Access Compliance Report

Public Rights-of-Way

(Curb Ramps)

| Intersection ID: 46374 | Main Street: HONOR_GUARD_AV | Cross Street: DUPPLIN_CASTLE_CT | Location: SW |

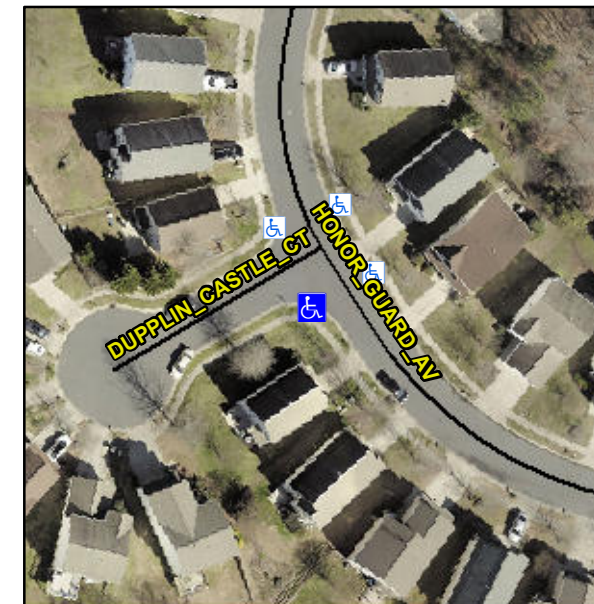
| ADA ID: F004B622AE37 | Ramp Type: PerpDiag | Initial Pass/Fail: Fail | Overall Compliance: No |

Not Found, R304.5.1, R304.5.3

| Compliance | Description | Data | Compliance | Description | Data |
|------------|-----------------------|-------|------------|-----------------------------|------|
| N/A | Ramp Length (in) | 47.0 | Yes | Ramp Slope (%) | 6.7 |
| No | Ramp Width (in) | 38.0 | No | Ramp XSlope (%) | 3.8 |

Remove & Replace Curb Ramp With Two New Directional Ramps or Equivalent.
